**Federal Highway
Administration**

September 29, 2005.

Thank you for writing on this subject. If you have any questions, please feel free to contact Mr. Scott Wainwright of our staff at scott.wainwright@fhwa.dot.gov or call him at 202-366-0857. Please note that we have assigned your request the following official interpretation number and title: "4-293(I)—APS Pushbutton Locations." Please refer to this number in any future correspondence on this matter.

Figure 4E-2. Recommended Pushbutton Locations for Accessible Pedestrian Signals

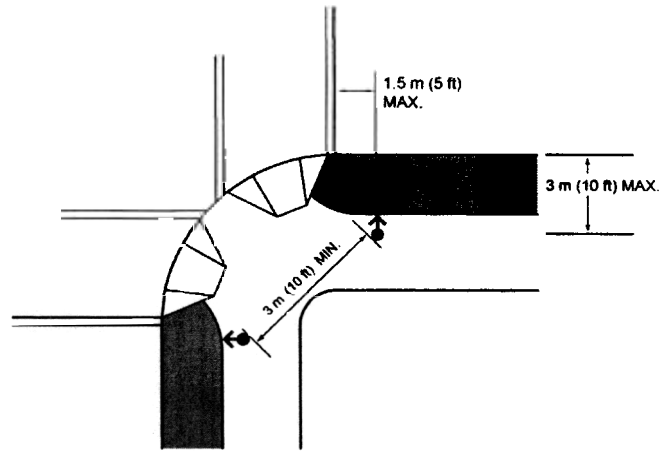
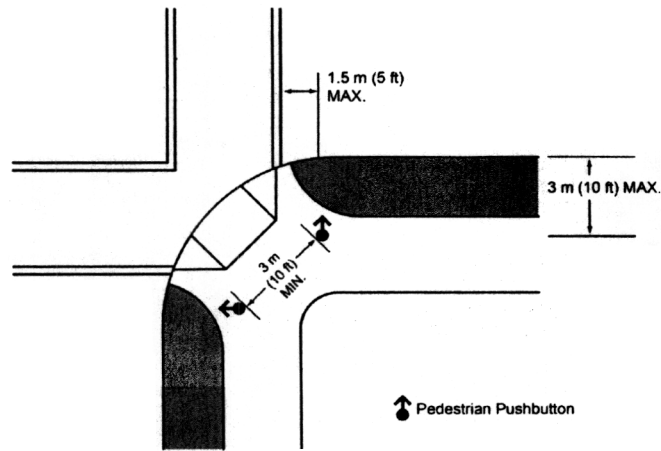
In Figure 4E-2, the two diagrams do appear to show the recommended 10 feet maximum distance from the curb as being dimensioned from the tangent section of curb. However, the figure does not accurately depict the intent of the text of Section 4E.09 as cited above as item C. The intent of the recommended maximum distance from the curb (in conjunction with the maximum of 5 feet from the crosswalk extended) is to keep the pushbutton location reasonably close to the point where a pedestrian enters the crosswalk, to minimize the time it takes a pedestrian to enter the crosswalk after actuating the pushbutton. For vision-impaired pedestrians this is a very important aspect of the design. Typically those pedestrians will remain near the APS pushbutton while awaiting the Walk signal, listening for the tone or feeling the vibrotactile surface. When the Walk signal does come on, if the pushbutton is located further than the recommended 10 feet from the entry to the crosswalk, the excess distance can negatively impact the ability of the pedestrian to complete the crossing within the allocated time.

I am a traffic signal designer working for Snohomish County Public Works, in Washington State. I am writing to ask for a clearer interpretation of one of the figures in the Millenium Edition of the MUTCD. Figure 4E-2, Recommended Pushbutton Locations for Accessible pedestrian Signals shows the recommended ADA-compliant locations for the ped pushbuttons. The ten-foot dimension shown appears to be measured from the face of curb on the tangent. It could also be interpreted to be measured from the point where the crosswalk line intersects the curb line. If that second interpretation is correct it will have an impact on typical County signal designs.

It is therefore our official interpretation that the recommended maximum distance of 10 feet as stated in item C above is measured from the curb, shoulder, or pavement at its closest point, regardless of whether that point is on the tangent section of curb or road edge or along the corner radius. This would correspond with "Example 3: 10' Dimension Measured as an Offset Arc from Face of Curb" in the attachment to your letter.

THREE EXAMPLES OF INTERPRETING
 FIGURE 4E-2, "RECOMMENDED
 PUSHBUTTON LOCATIONS FOR
 ACCESSIBLE PEDESTRIAN SIGNALS",
 MILLENNIUM EDITION OF THE MUTCD.

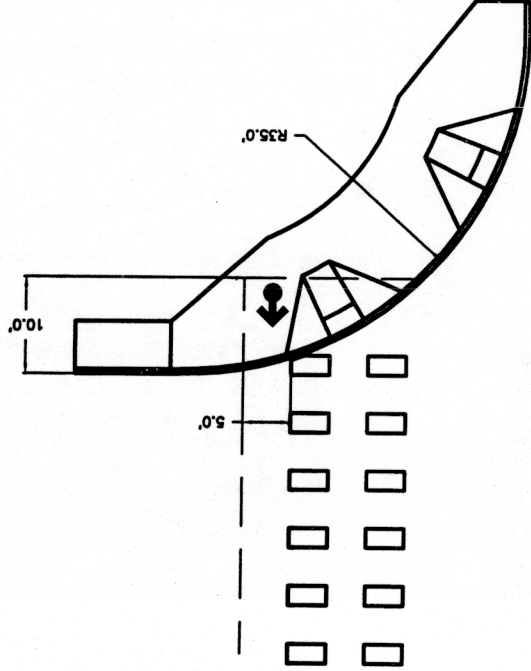
Most of our designs are new urban traffic signals and we typically use a 35-foot radius for the curb line. If the ten-foot dimension controlling the pushbutton location is measured from the point where the crosswalk intersects the curb line, then that point is about one-and-one-half feet farther from the face of curb than if that point is measured to the tangent.

I've included a drawing of these two interpretations. I have also drawn up a third interpretation, where the ten-foot dimension is measured along the face of curb resulting in an arc within the sidewalk. The second and third interpretations of the figure give me more flexibility in locating signal poles and pushbuttons. Which interpretation is correct? I would appreciate all insight you can provide me in this matter.
